ABERDEEN MIDDLE SCHOOL
HVAC SYSTEMIC RENOVATION

ADDENDUM NO. 5

DATE: April 3, 2024

PROJECT: Aberdeen Middle School
HVAC Systemic Renovation
111 Mt. Royal Avenue
Aberdeen, Maryland 21001
Gipe Project No. 23043

1 LOWER LEVEL REFLECTED CEILING PLAN
A104 1/16" = 1'-0"

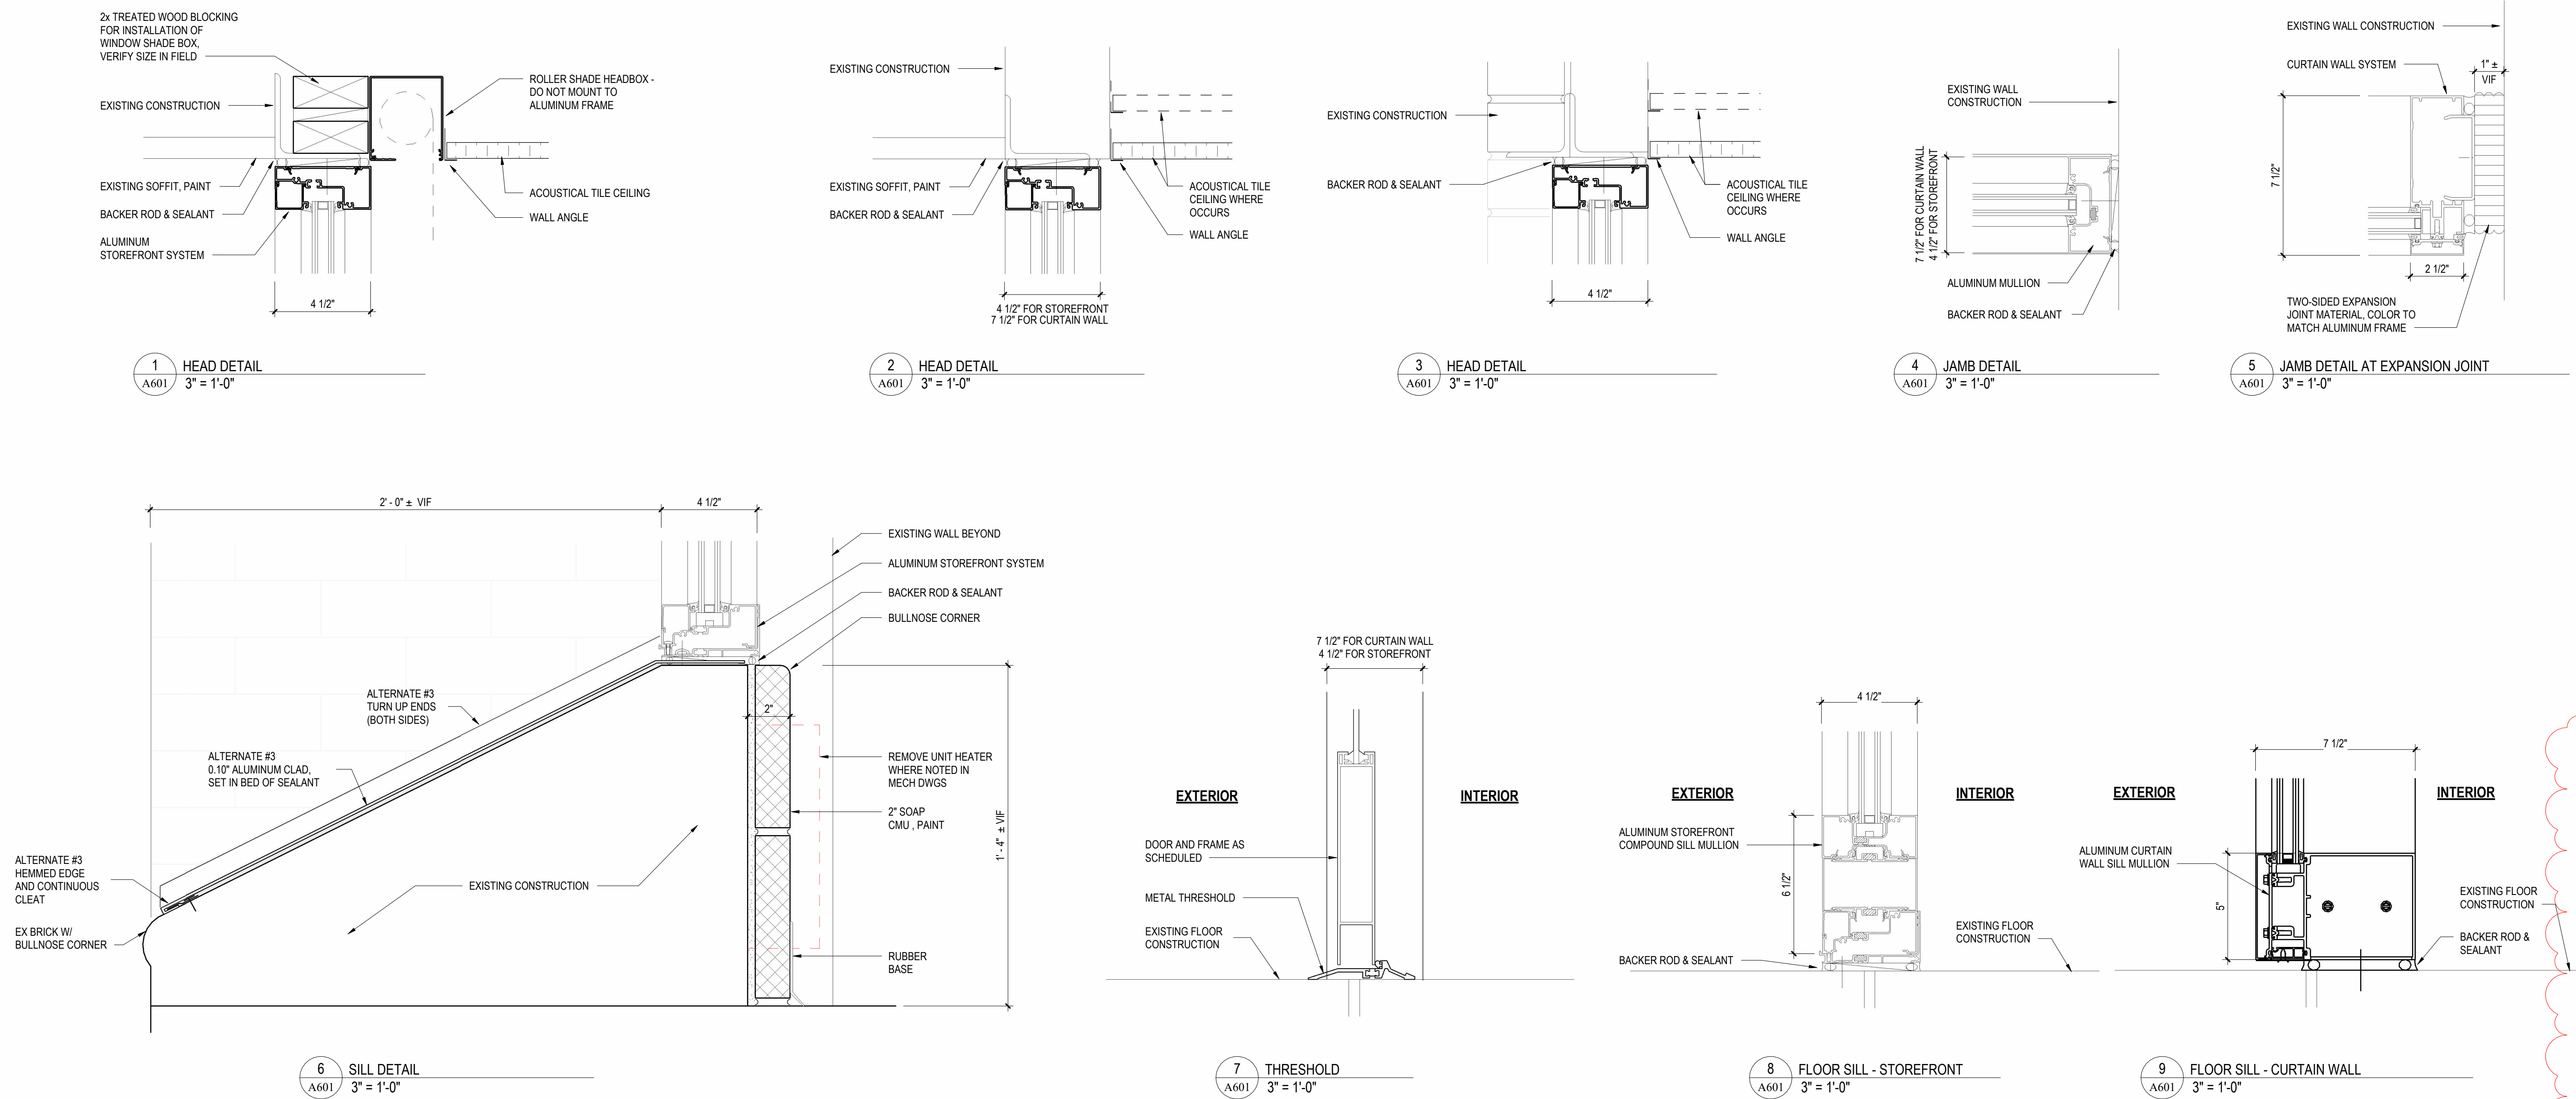
1. AD101 – LOWER LEVEL DEMOLITION PLAN
See attached revised drawing AD101.
2. A104 – LOWER LEVEL REFLECTED CEILING PLAN
See attached revised drawing A104.

DOOR SCHEDULE AND FRAME DETAILS

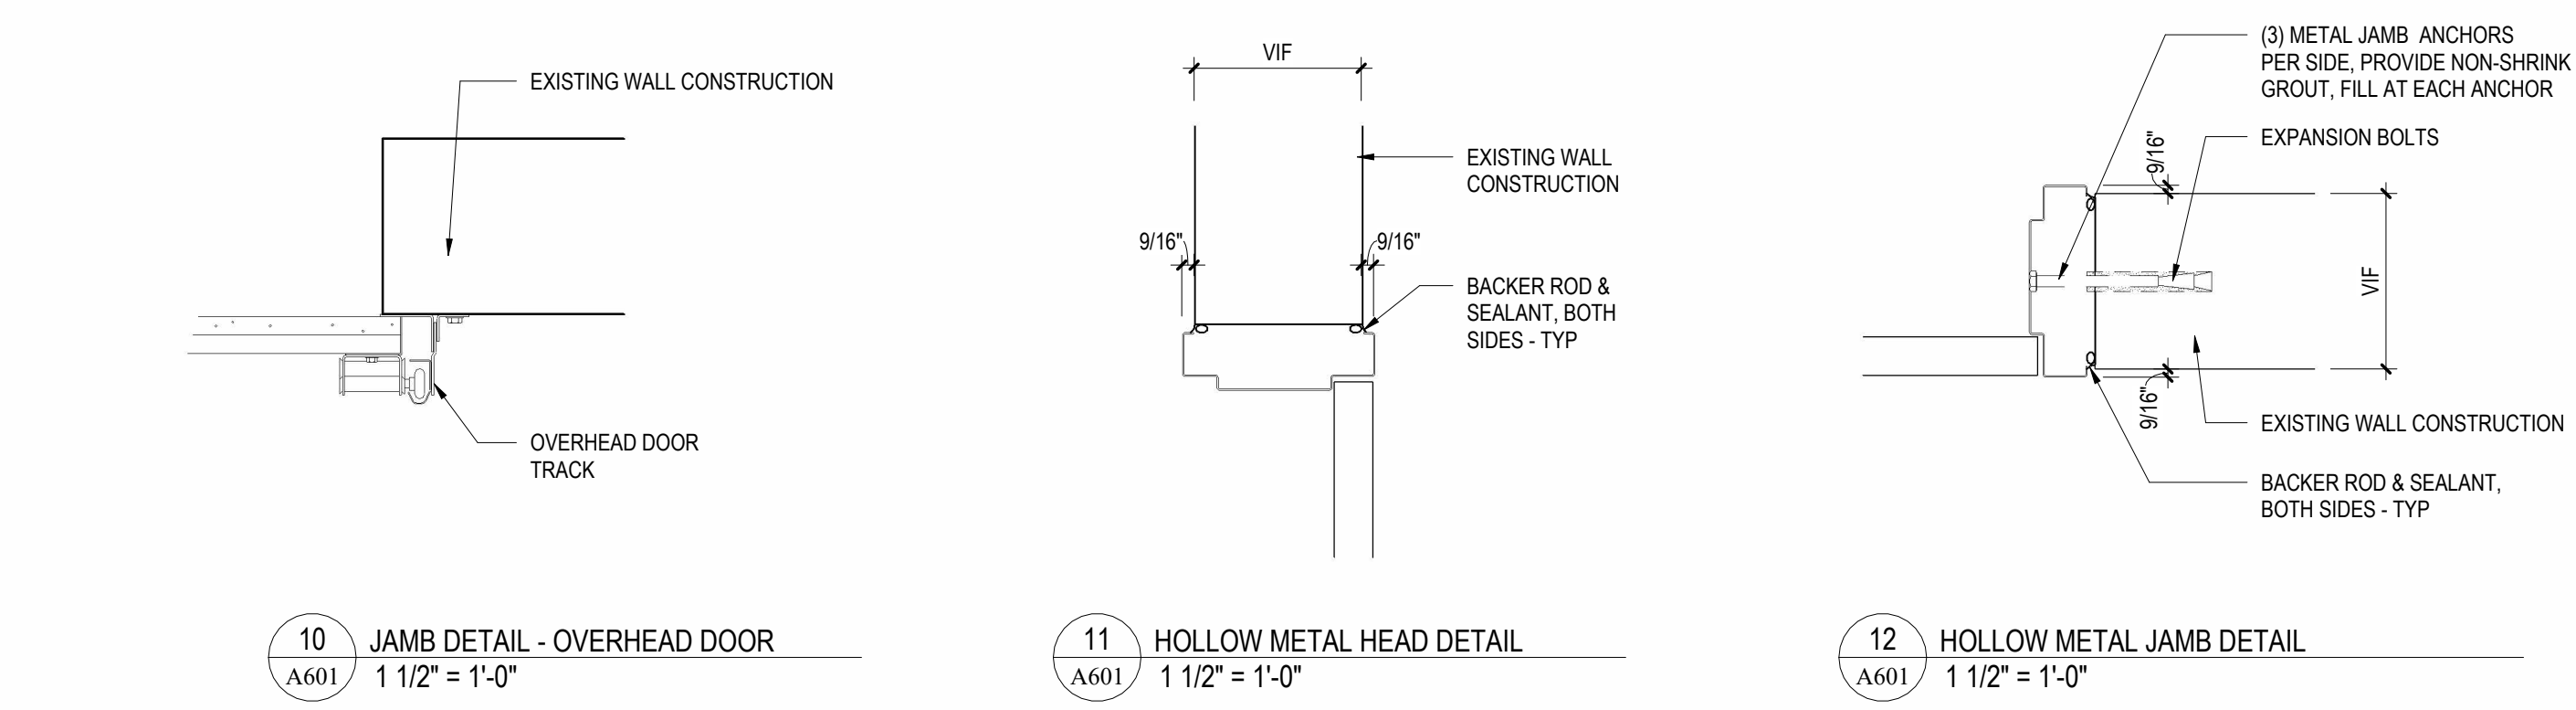
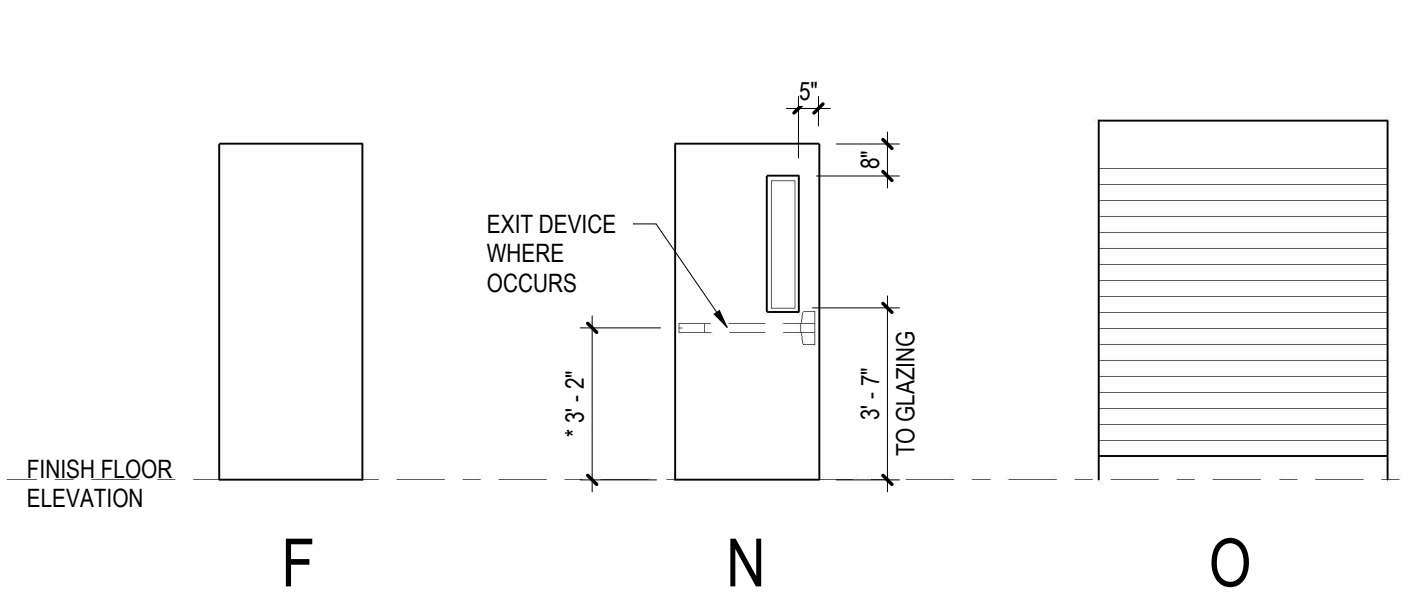
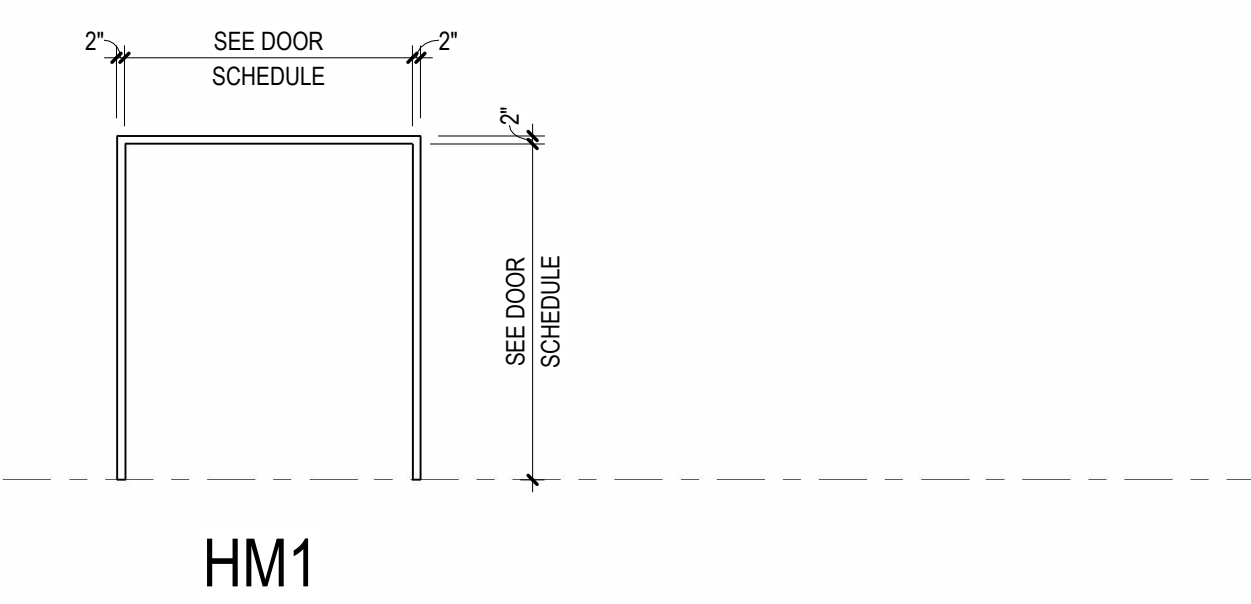
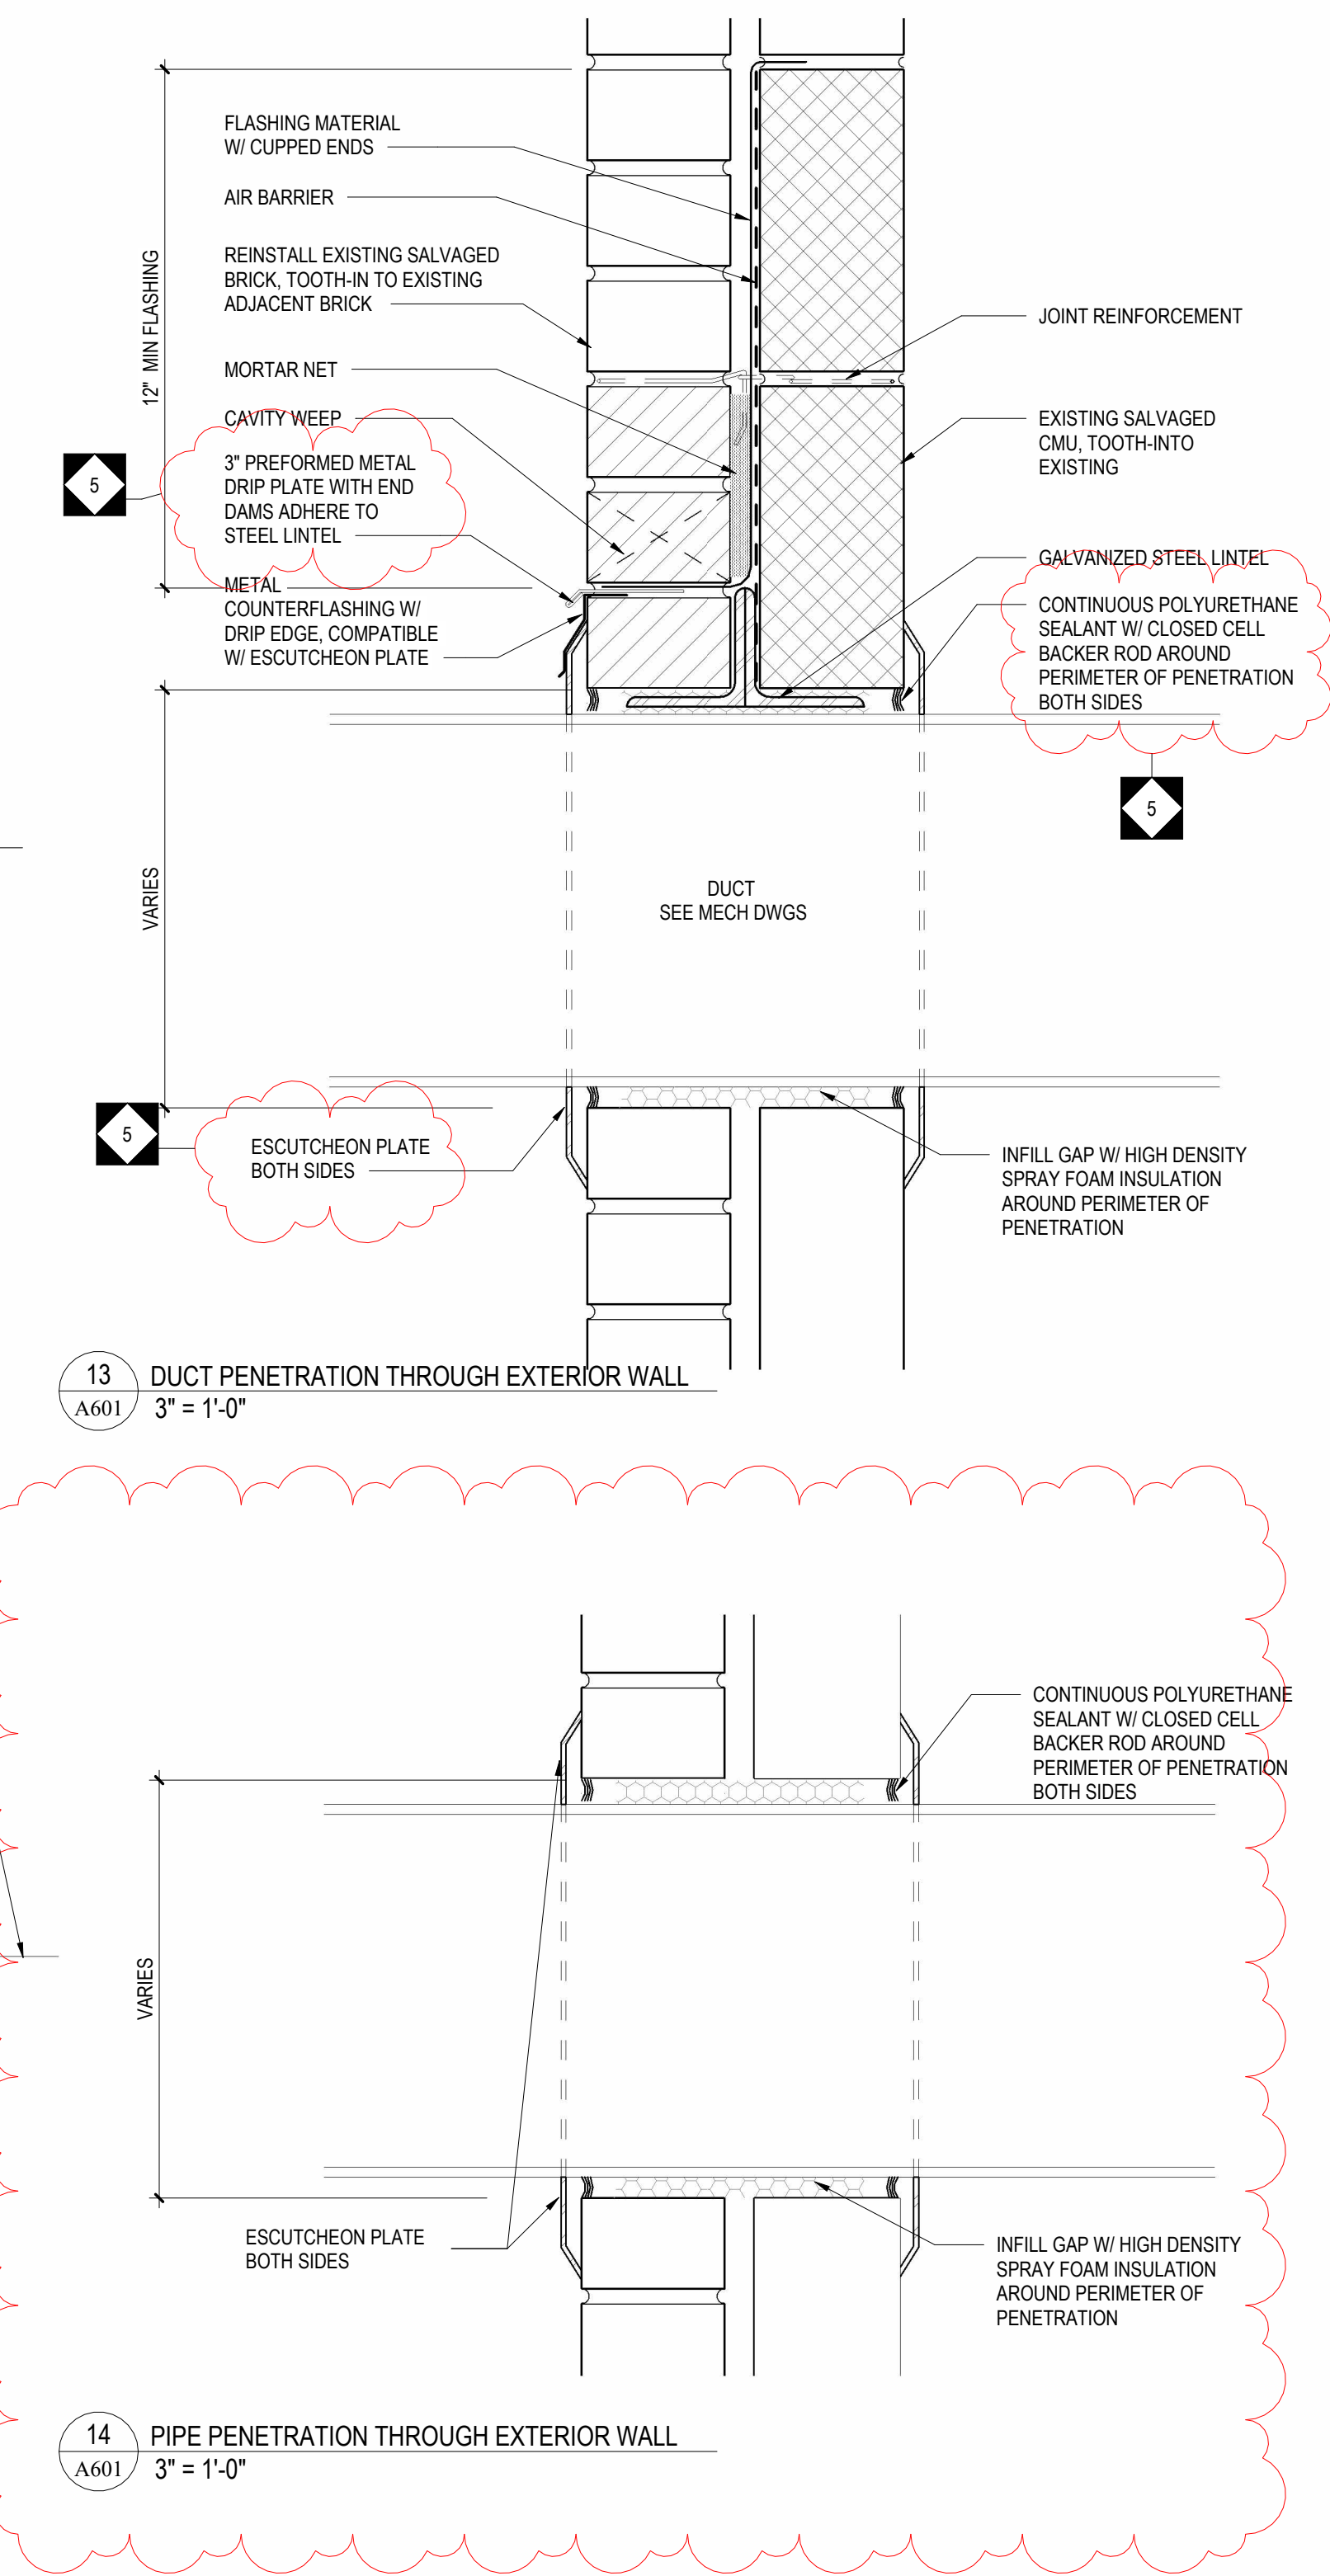
3. A601 – DOOR SCHEDULE AND FRAME DETAILS
See attached revised drawing A601.
4. S101 – UPPER LEVEL FRAMING PLAN-AREA F AND CHILLER PADS PLAN
Add project key plan at the bottom left of sheet.
